City of Garden Grove

Site C

Subsequent Mitigated Negative Declaration

Response to Comments (RTC)

Exhibit 3-4 City of Garden Grove Master Plan of Bikeway Facilities

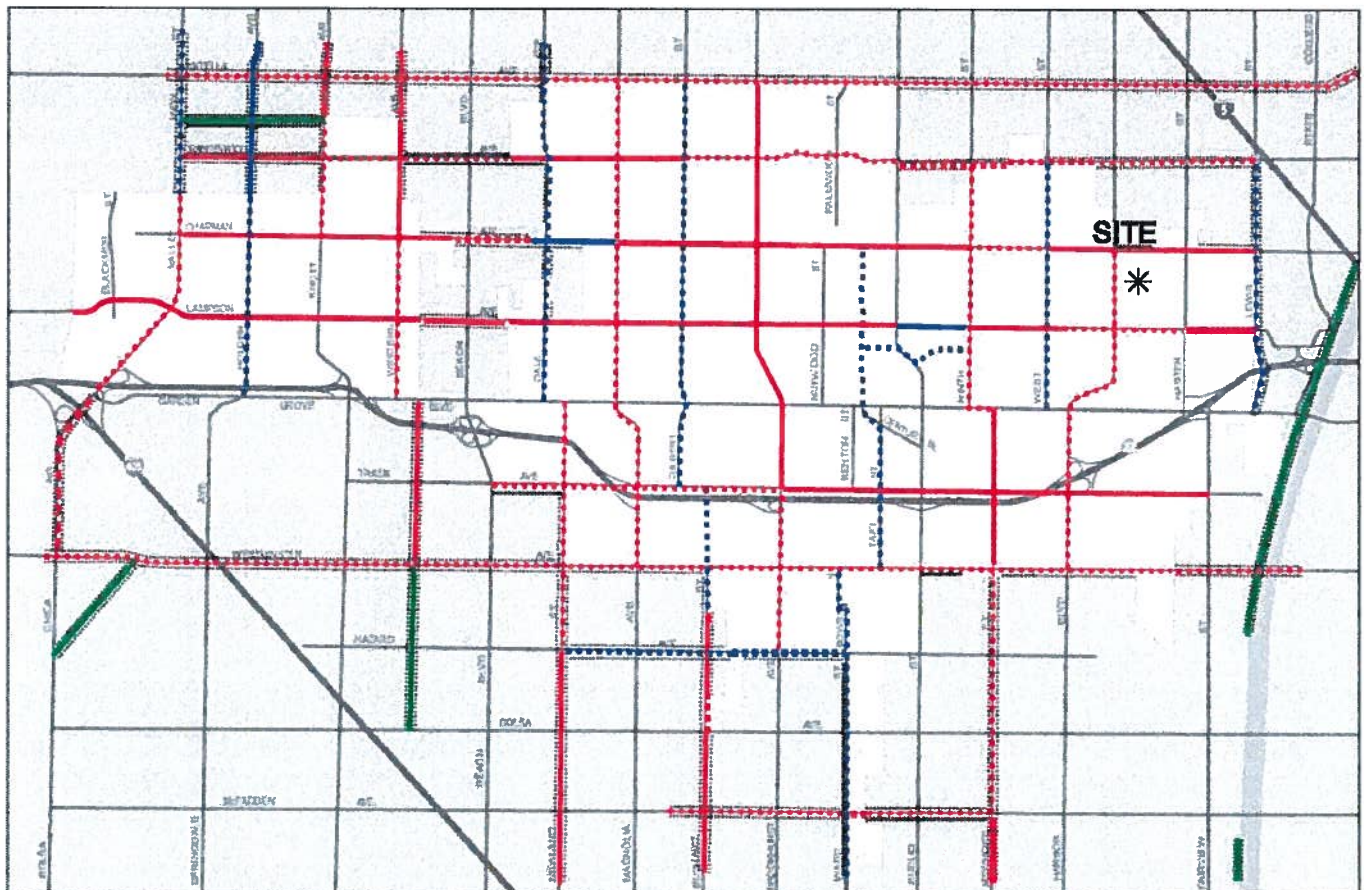
- Regarding Exhibit 3-4 (City of Garden Grove Master Plan of Bikeway Facilities) – This map shows bike lanes on Katella Avenue in the City of Anaheim which is not consistent with the City of Anaheim's recently adopted Bicycle Master Plan (adopted on May 23, 2017, see page 31 of the following link: <http://www.anaheim.net/DocumentCenter/Home/View/2027>).

Anaheim-2 The comment is acknowledged. Please note that Exhibit 3-4 of the Traffic Impact Study was based on the City of Garden Grove Bikeway Master Plan. However, to address this discrepancy (bike lanes on Katella Avenue) between the City of Garden Grove Bikeway Master Plan and the City of Anaheim Bicycle Master Plan, a note has been added to Exhibit 3-4 to correct this issue. See the revised Exhibit 3-4 on the next page.

Please note that the bike lanes on Katella Avenue are no longer proposed per the City of Anaheim Bicycle Master Plan which was adopted on May 23, 2017.
